GROWTH MANAGEMENT DEPARTMENT STAFF REPORT
VILANO BEACH TOWN CENTER OVERLAY DISTRICT

October 11, 2023 Public Meeting
VBTCDR 2023-05 Vilano Mixed Use

Architectural Review Comments
Vilano Beach Town Center
Beach at Vilano
VBTC DR 2023-05

Prepared by
Donald A. Crichlow, AIA
FL. Lic. AR0015950
September 20, 2023

SITE PLAN

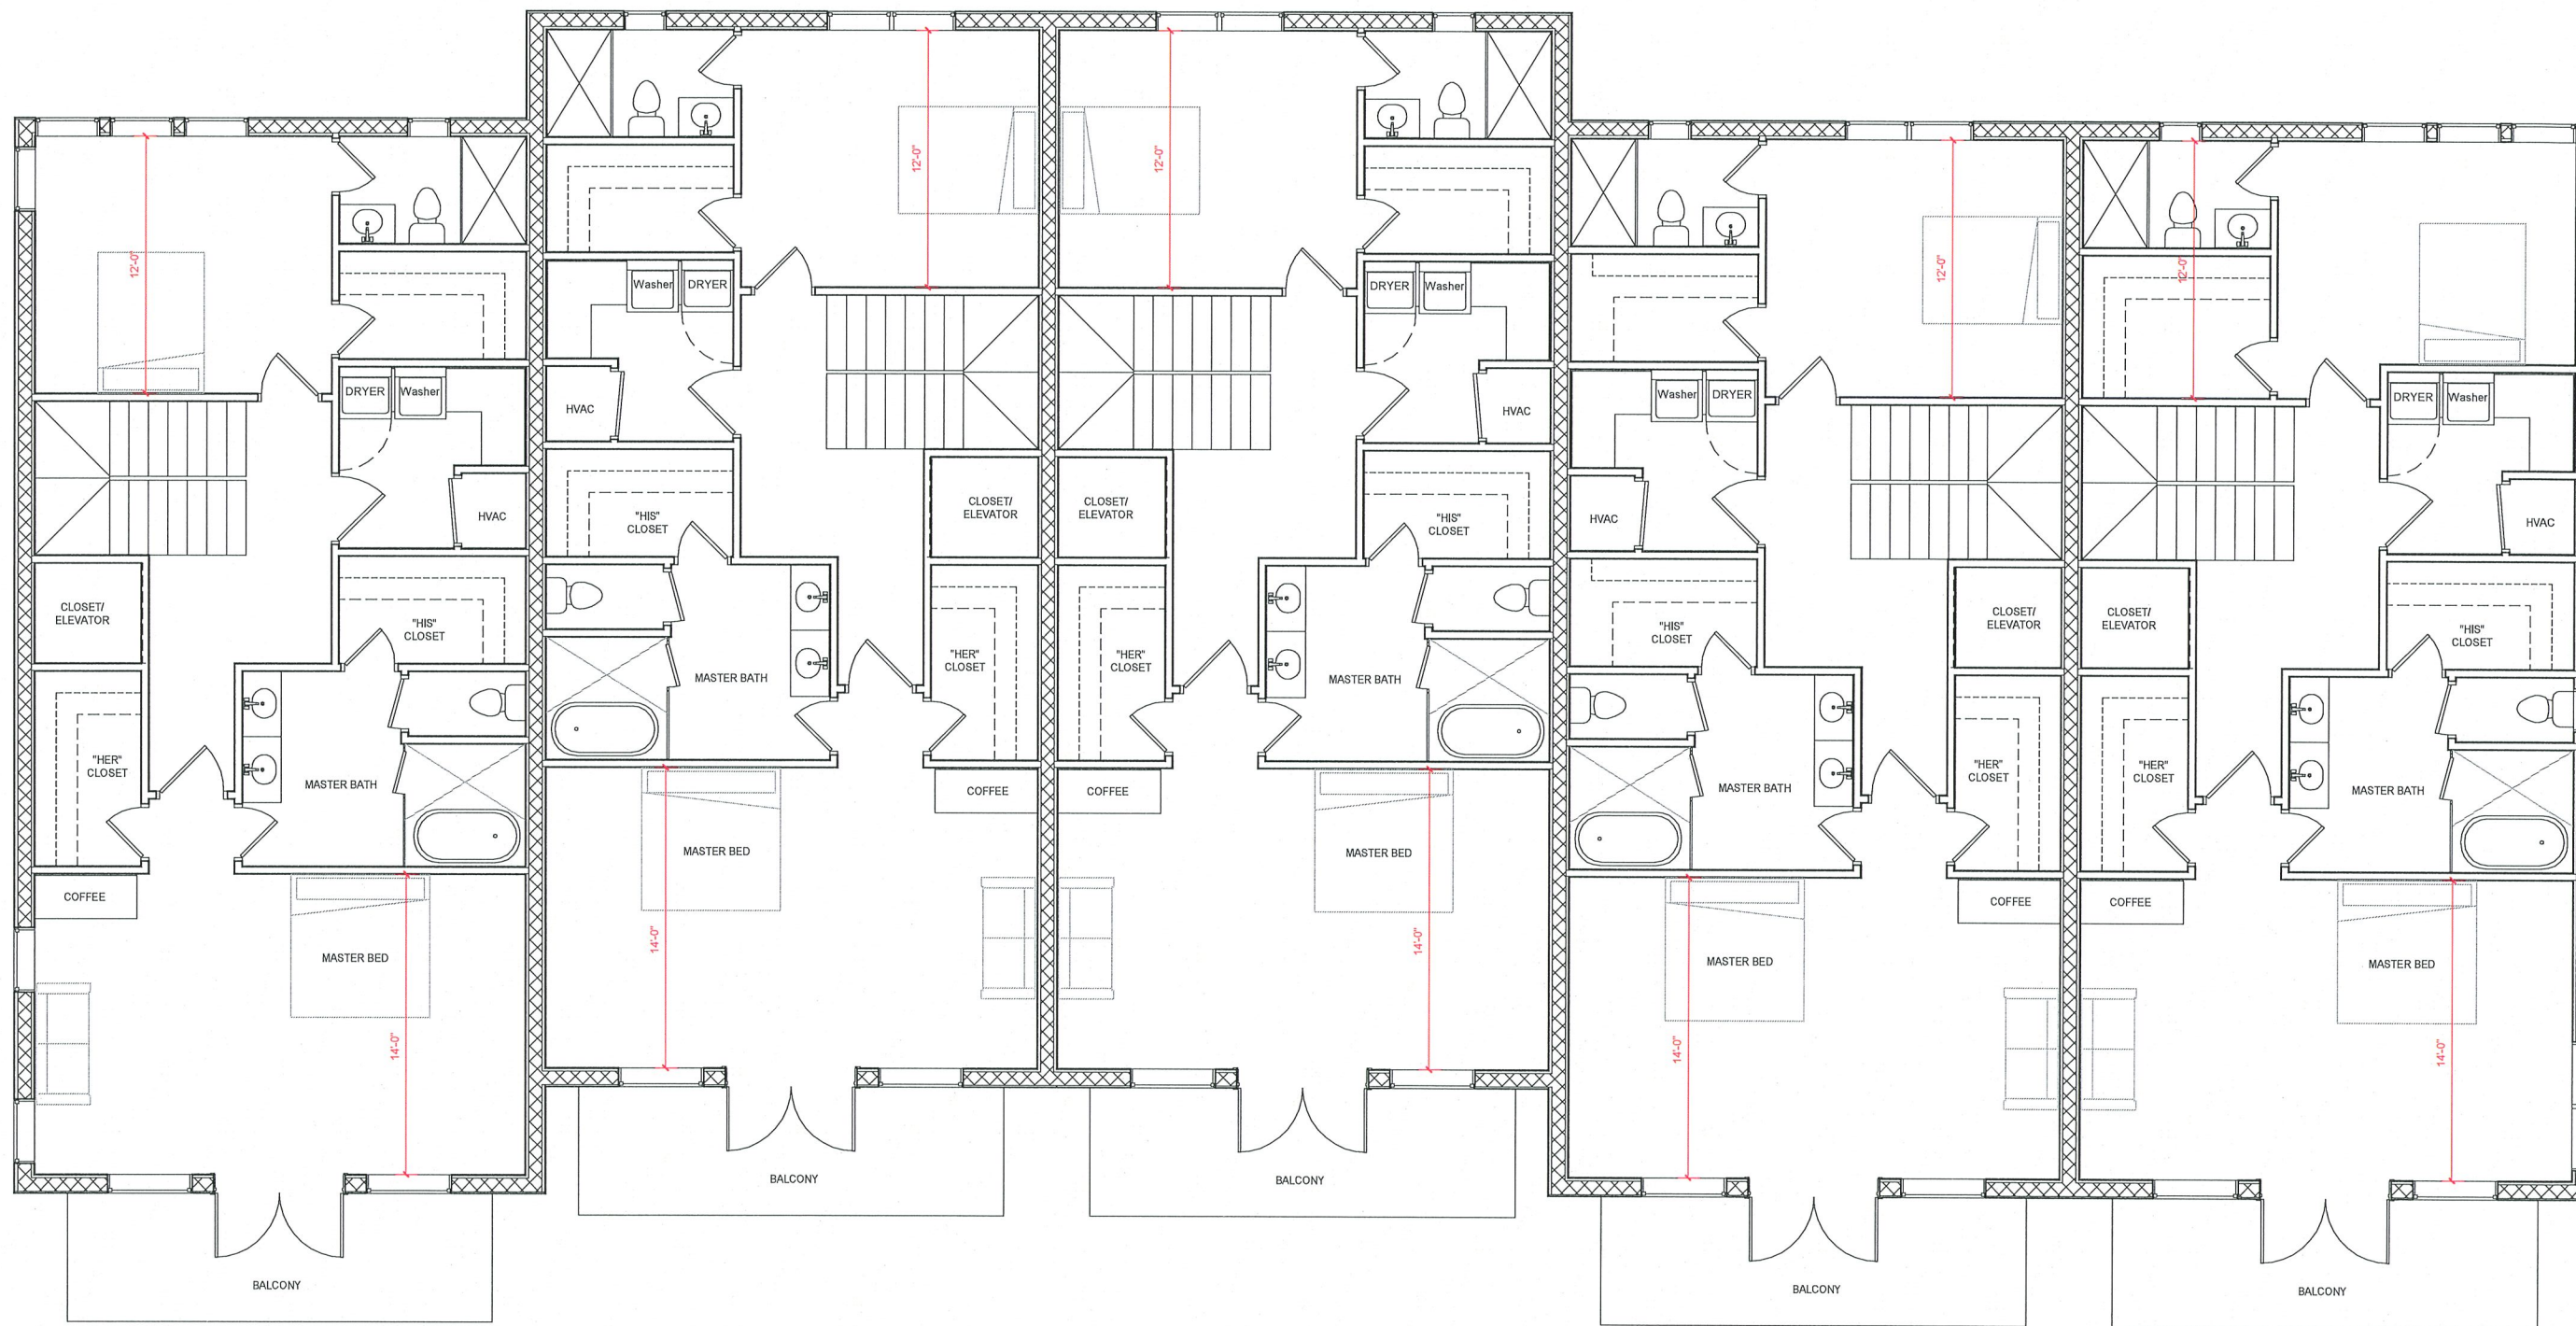
The plans show underground parking and garages with the multi-family units. The VBTC requires one space per dwelling unit. There are 16 multifamily dwelling units proposed requiring 16 spaces and four tourist homes proposed requiring four spaces. The site plan show sufficient parking for the residential units. The site plan depicts commercial parking, which is not part of this approval.

Section 3.10.04.A.9. Transmission, phone and cable boxes will be placed in the rear of the development and decorated in a manner compatible with the architectural style of the building. These utility elements are not shown on the site plan. The DRB may want to ask the applicant to provide where such utility elements are located and how those are screened.

Section 3.10.04.A.17. Accessways, driveways and access points are shown on the site plan.

Section 3.10.05.J. Parking. The plans show underground parking and garages with the multi-family units. The VBTC requires one space per dwelling unit. There are 16 multifamily dwelling units proposed requiring 16 spaces and four tourist homes proposed requiring four spaces. The site plan show sufficient parking for the residential units. Please note the site plan depicts the commercial parking, which is not part of this approval. Parking will be reviewed with the construction plans.

ELEVATIONS

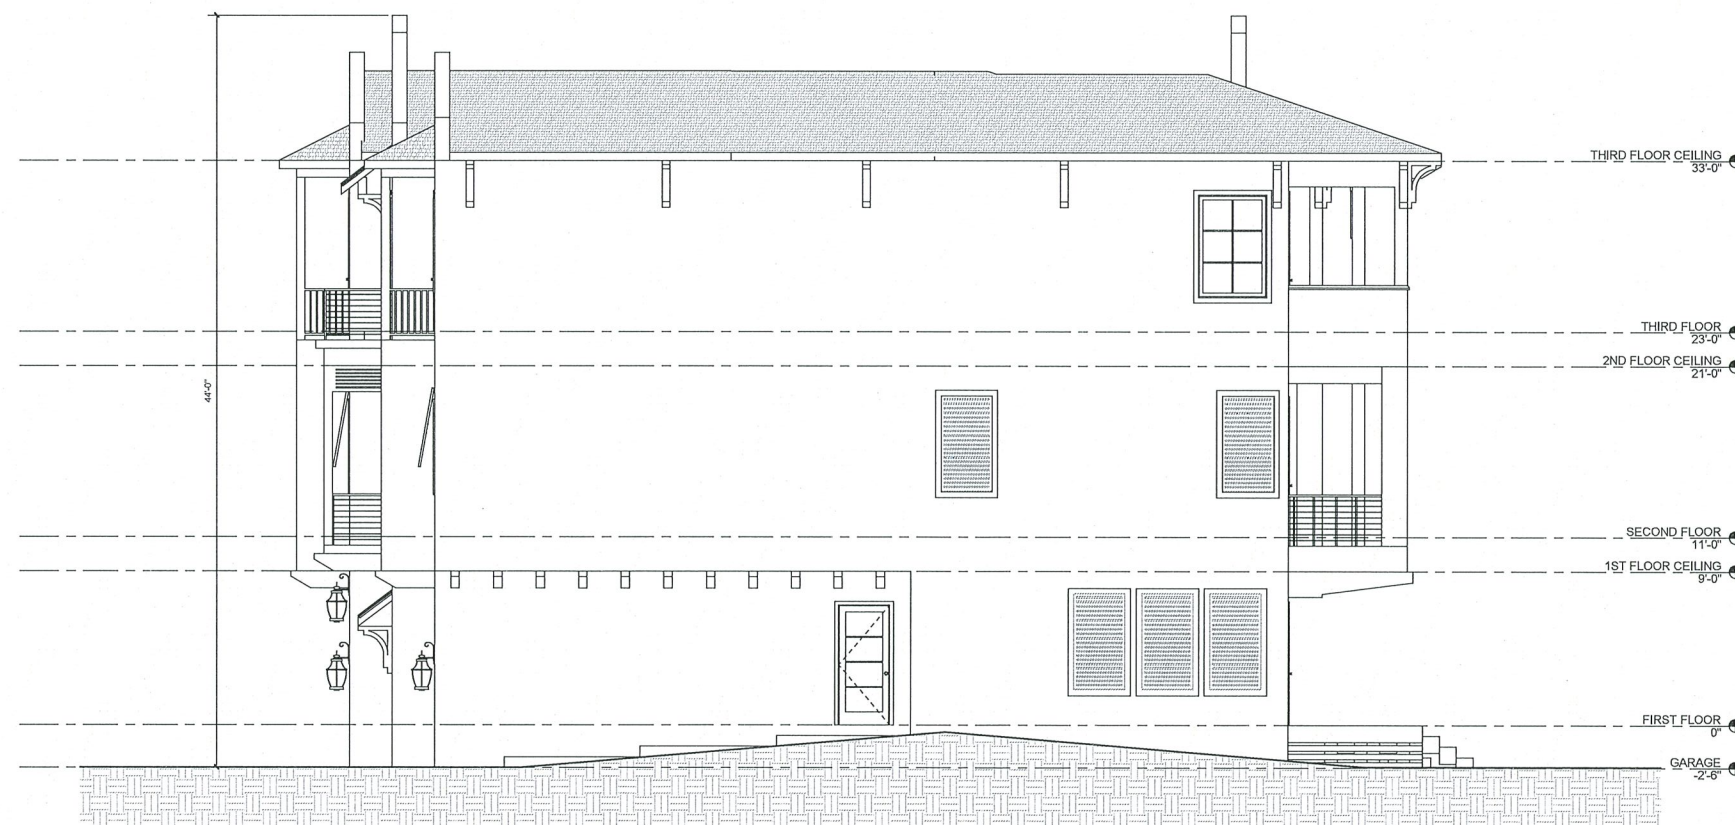
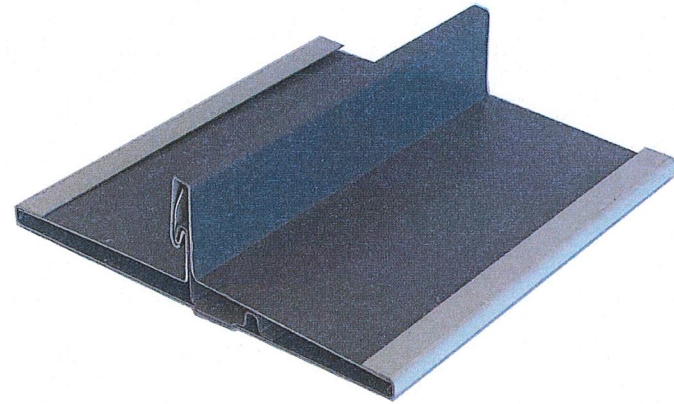
The windows appear to be consistent with the Overlay guidelines in both size and light configuration. Bahama shutters, although not technically a feature of Florida Vernacular or Old Florida Beach, are pictured in the Overlay guidelines and so I assume they are acceptable in the Overlay District. Some of the shutters appear to be fixed on some buildings and some operable. The Overlay guidelines state that if shutters are used on some windows, they must be used on all windows. This does not appear to be the case on this project with Bahama shutters indicated on the lower floors but not on the upper levels.

A variety of balcony railings are utilized on the buildings. All appear to be metal or horizontal cable railings. Some railings are vertical pickets with Chippendale design inserts. The Chippendale style originated in 18th century Europe. It is most appropriate for buildings in the Georgian or Federal Style or Colonial Revival. Although the Chippendale style railing is popular on Southeast coastal homes, Chippendale and Florida Vernacular are competing design motifs.

With the exception of the dark wood features on the buildings (i.e., columns, garage doors, railings and eave brackets), the wall colors appear to meet the Overlay guidelines.

The proposed roof design on all buildings is a low slope, metal roofing and appear to be of a silver color consistent with the Overlay Guidelines.
